# WETLANDS NOTICE OF INTENT

## PROPOSED WORKSHOP BUILDING

Precourt Stone  
46 Union Avenue  
Sudbury, MA 01776

The Horsley Witten Group, Inc. (HW) is pleased to provide the Sudbury Planning Board with this letter report summarizing our second review of the proposed development at 44 & 46 Union Avenue. The Project Area includes the Precourt Stone facility office and storage yard, a property owned by the Union Avenue Realty, LLC. The Precourt Stone property covers approximately 5.75 acres over 3 separate parcels. Approximately 0.88 acres comprises the “rear” parcel, a material storage yard where the work is being proposed.

## FIGURE 2

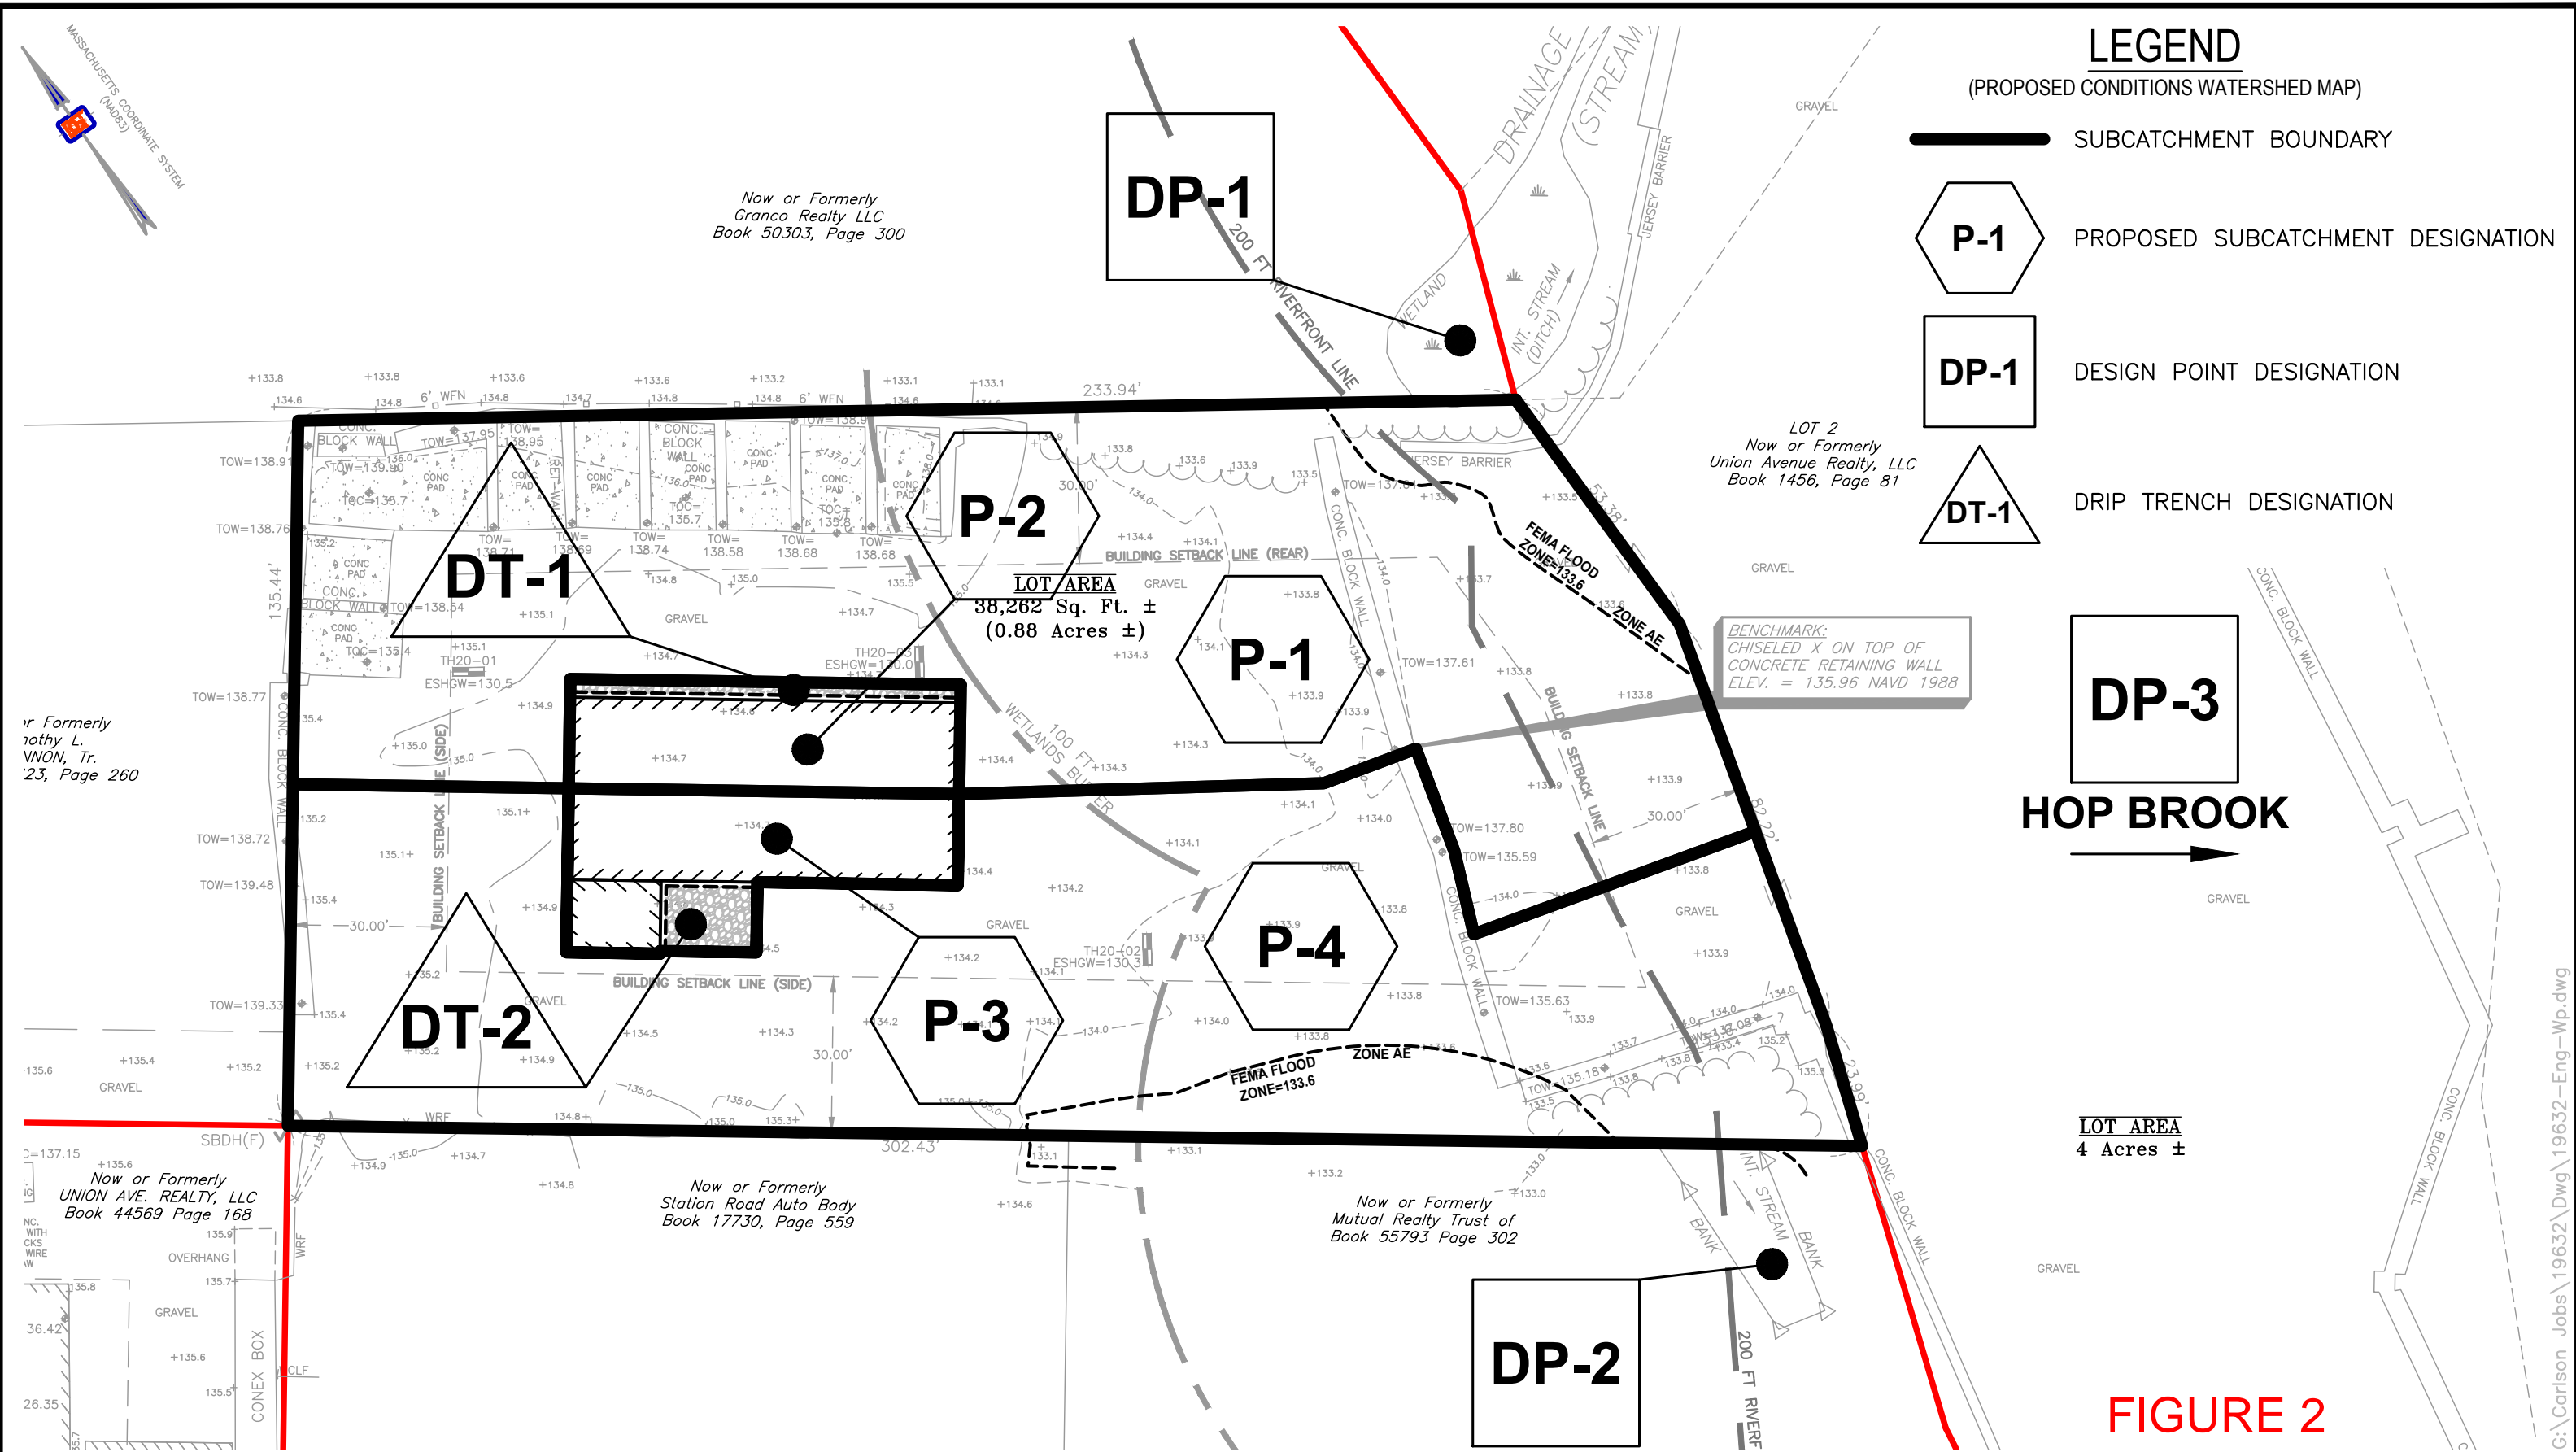
- a. HW notes that the HydroCAD model subcatchment numbers are not consistent with the catchment areas illustrated on the Post-Development Watersheds, Figure WSD-PR. HW was able to confirm the watershed areas listed in the HydroCAD model however recommends that Figure WSD-PR be revised for documentation purposes.

**The Applicant has revised Figure WSD-PR as requested. No further comment.**

**SITE OVERVIEW**

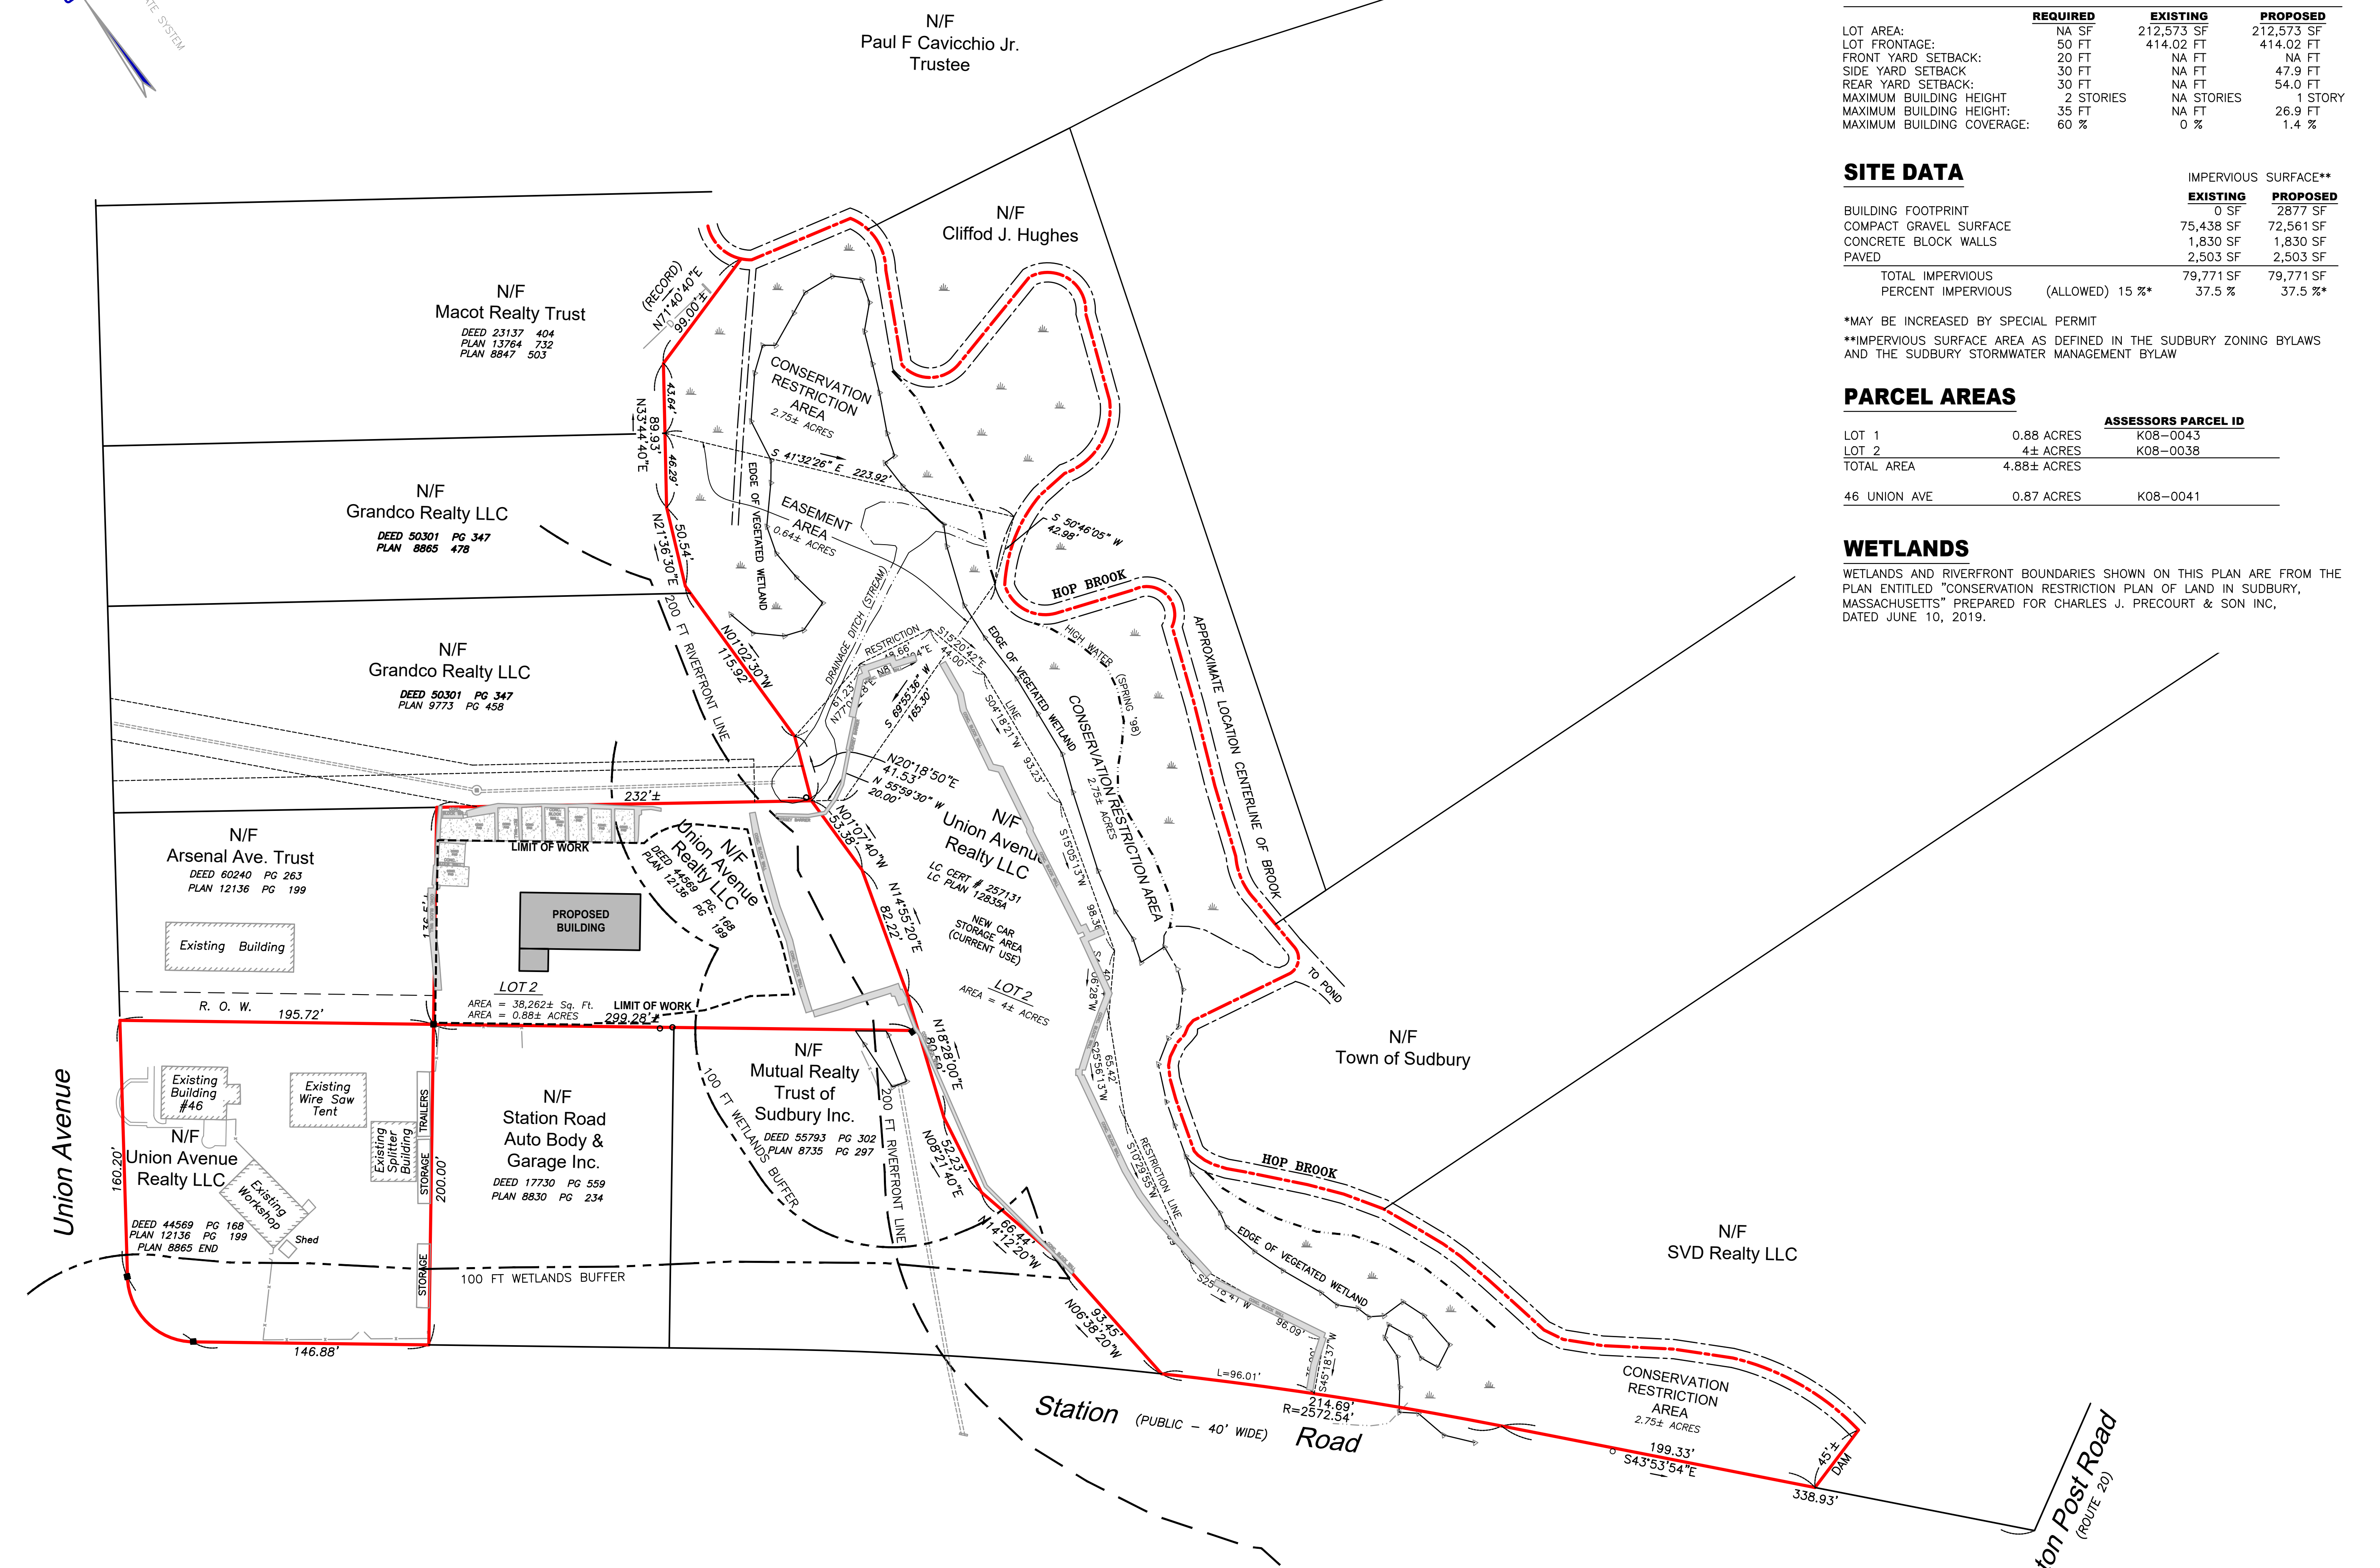
- a. The Applicant proposes a new workshop and utilities. It does not appear there is a defined limit of disturbance on the site. HW recommends that the Applicant delineate the limit of work on the Site Overview and the Site Layout and Grading & Drainage Plan sheets and confirm that no trees will be removed as part of the proposed development.

- b. The Applicant has illustrated the 100-foot wetlands buffer as well as the floodplain line but has not shown the limits of the 200-foot Riverfront Area on the plans. HW recommends that the Applicant add the 200-foot Riverfront Area to clarify no work is being conducted within this resource area.

**The Applicant has added the limit of work line as requested. No further comment.**

**The Applicant has added the 200-foot Riverfront Area limits as requested. No further comment.**

**STONE DRIP TRENCH**  
(NO SCALE)

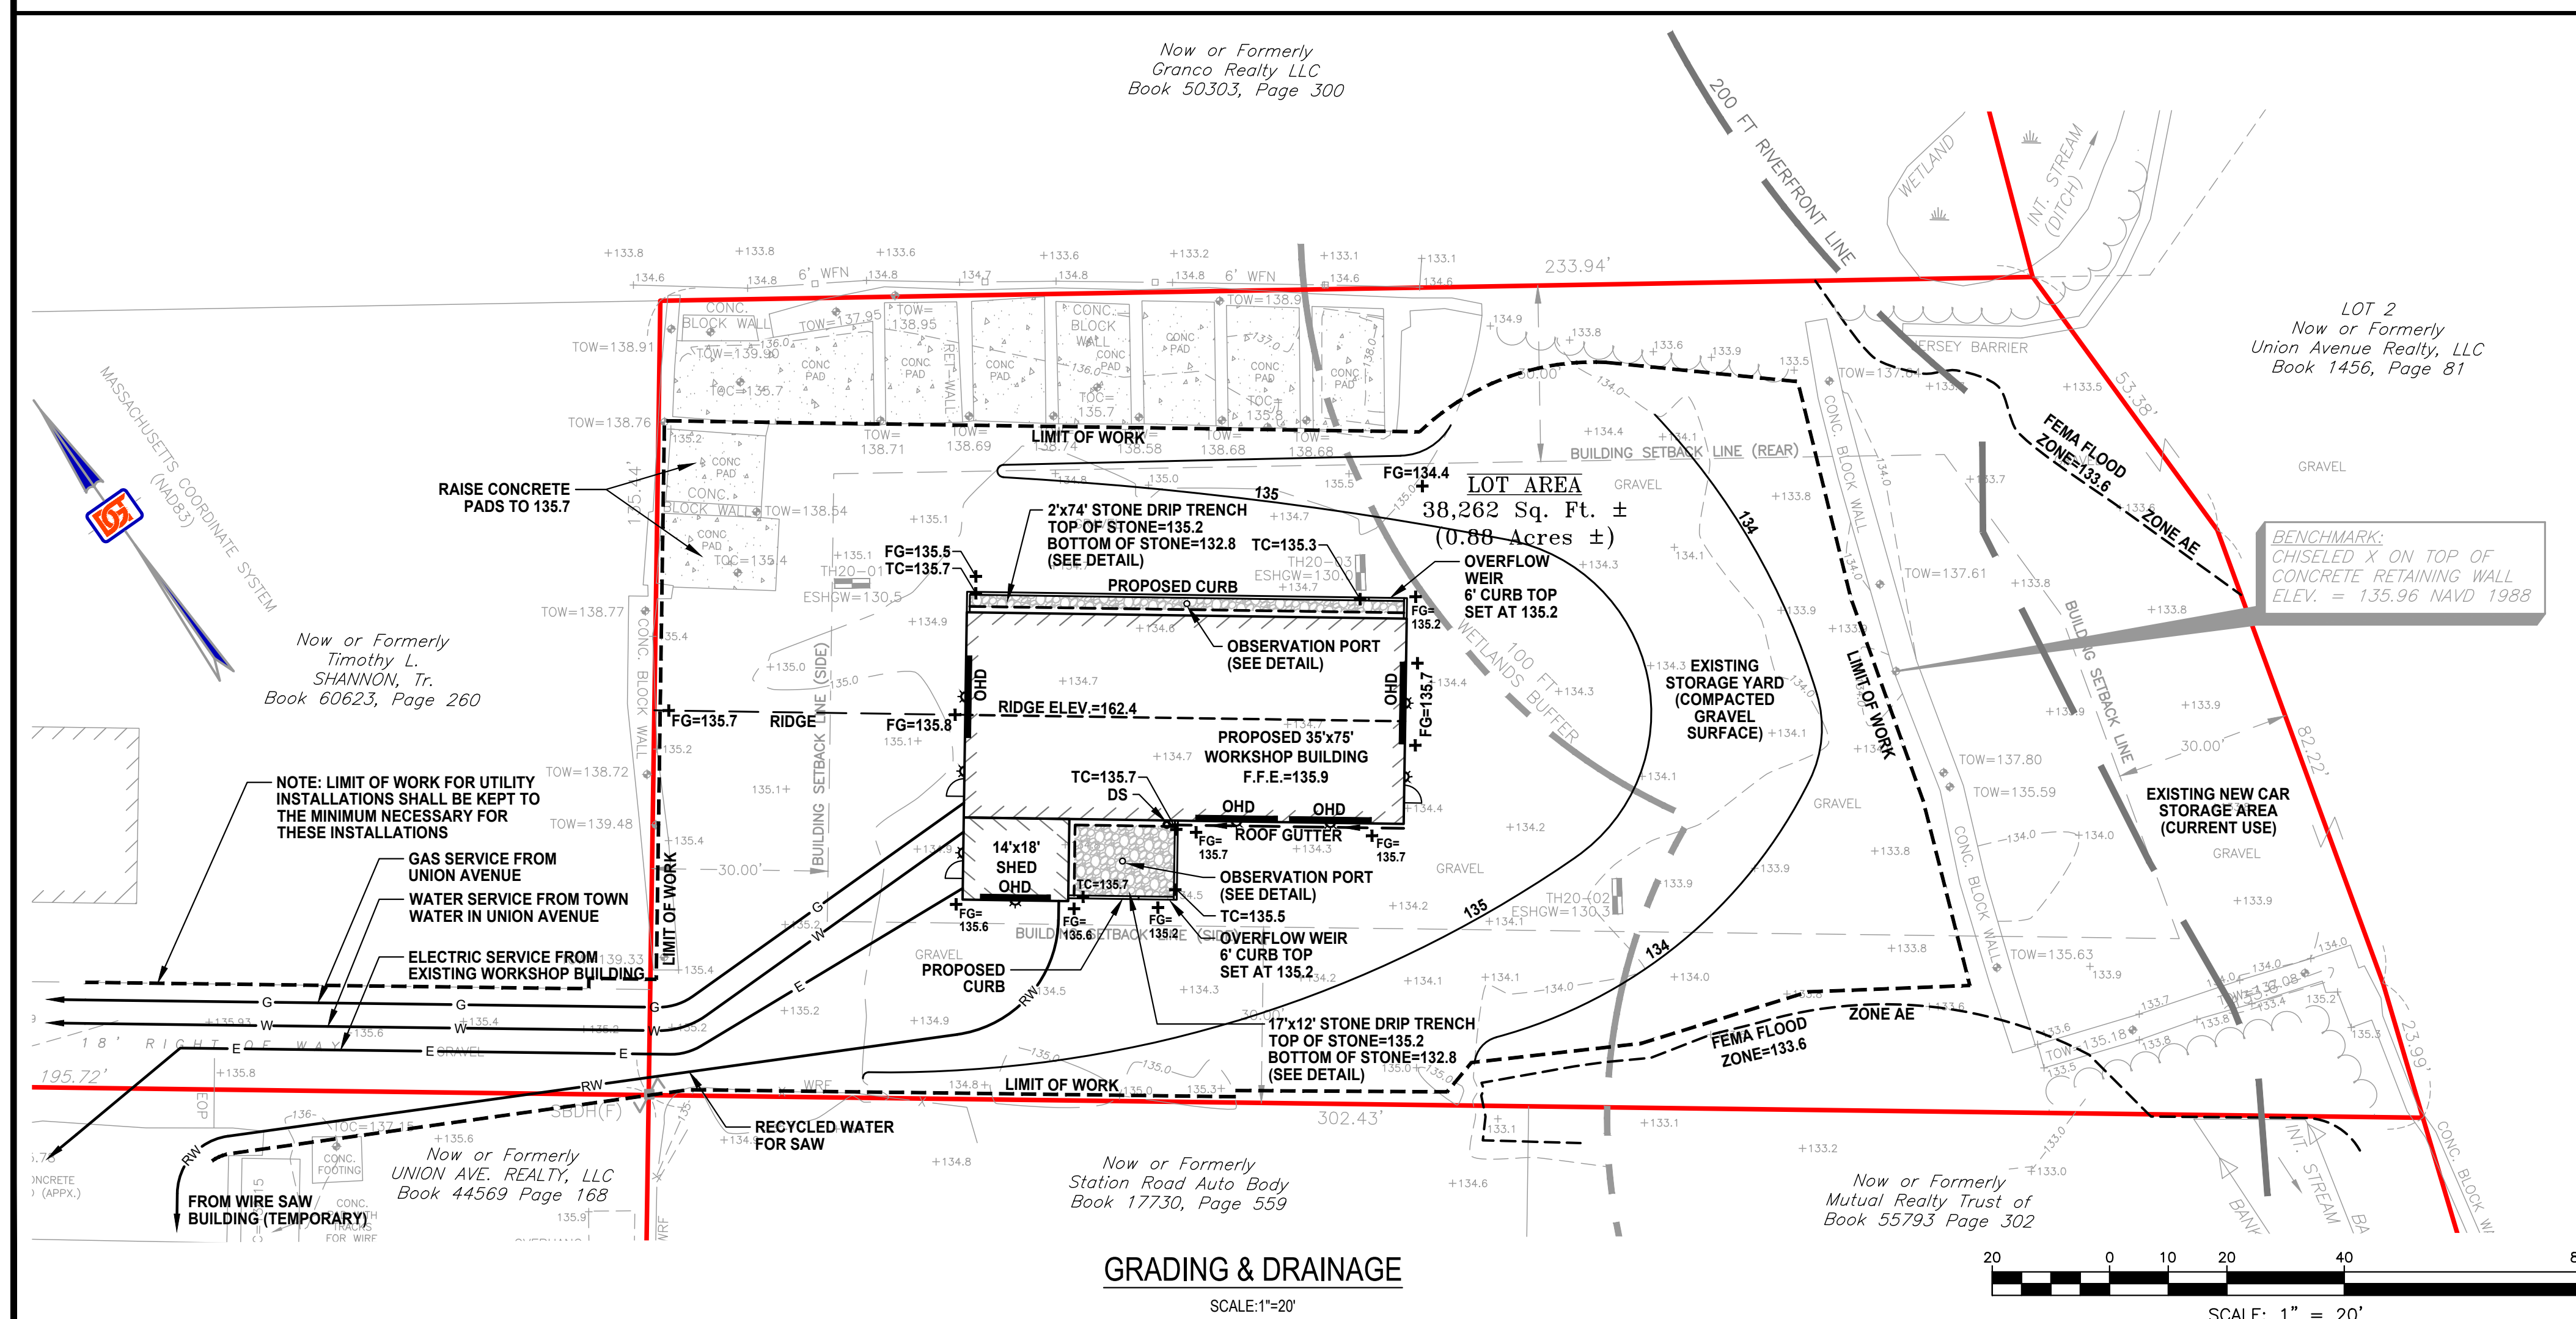
- a. The Applicant has conducted 3 test pits within the gravel yard. The estimated seasonal high ground water (ESHGW) elevation is between 130.0 and 130.5. The bottom of the stone trench is at 132.4. HW recommends that during construction the Applicant confirm that the bottom of the trench is located a minimum of 2 feet above the ESHGW. The Planning Board may consider requesting a letter from a soil evaluator confirming the separation at the time of installation.

**The Applicant has raised the bottom of the drip trench 0.4 feet to provide a minimum of 2 feet of separation above the highest ESHGW level recorded. No further comment.**
